**SUNDRY NOTICES AND REPORTS ON WELLS**  
*Do not use this form for proposals to drill or to re-enter an abandoned well. Use form 3160-3 (APD) for such proposals.*

8. Well Name and No.  
WEST TEAS UNIT 922

9. API Well No.  
30-025-29900-00-S1

**\*\* BLM REVISED \*\* BLM REVISED \*\* BLM REVISED \*\* BLM REVISED \*\* BLM REVISED \*\***

**Proposed**  
**Wellbore Diagram**

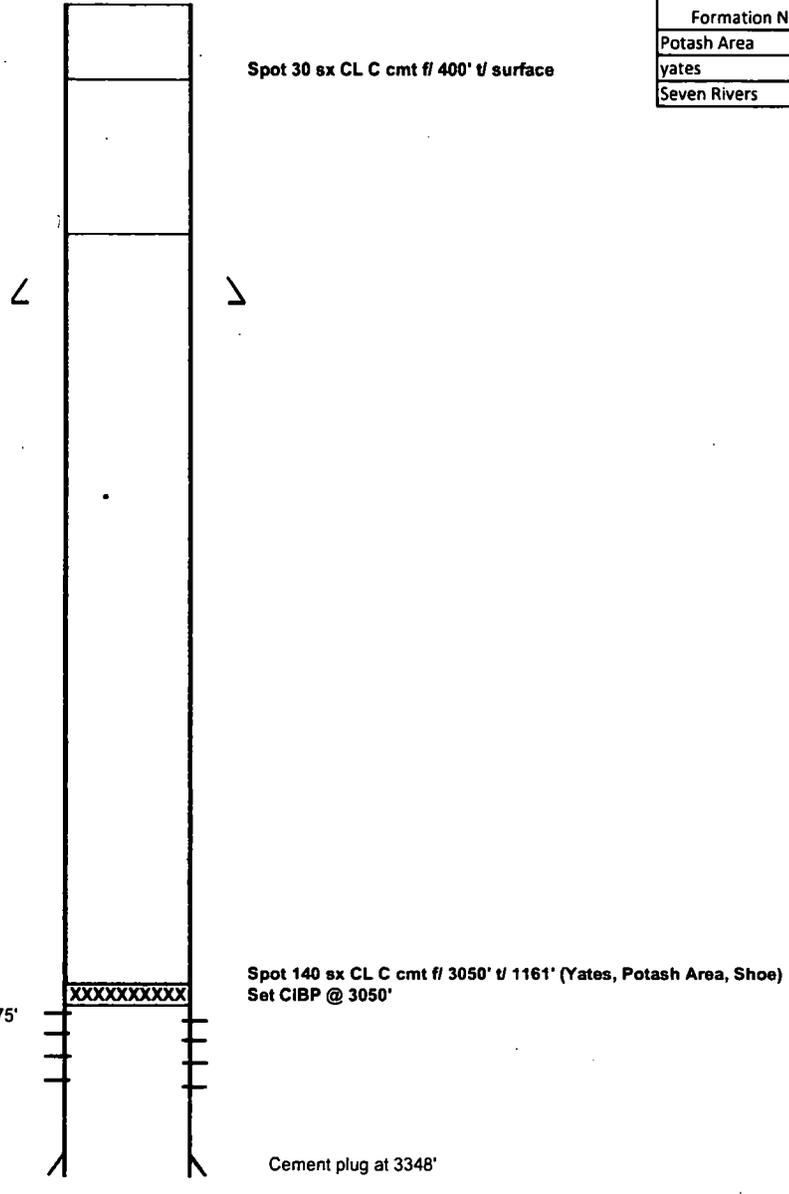
- Provide BLM with 24 hour notification prior to MIRU in accordance with applicable COAs
- MIRU, pull rods, N/U BOP, pull tubing
- Set CIBP @ 3050?, fill well with fresh water, pressure test casing to 500 psi for 10 minutes. *3052 Top 2952*  
If test passes, spot MLF.
- Spot 140 sx CL C cmt f/ 3050? U 1161? (Yates, Potash Area, Shoe). If casing test in step 3 was successful, do not WOC & tag. If casing test in step 3 was unsuccessful, WOC, tag, pressure test, and spot MLF. *Tag 1161*
- Spot 30 sx CL C cmt f/ 400? t/ surface (Fresh Water)
- Verify cement to surface and RDMO

*3-27-19 OK to Set*  
*LTAP@ 3052-2992.*  
*To Michael Steel.*  
*432.528-8564*

*Below ground level dry hole marker required*
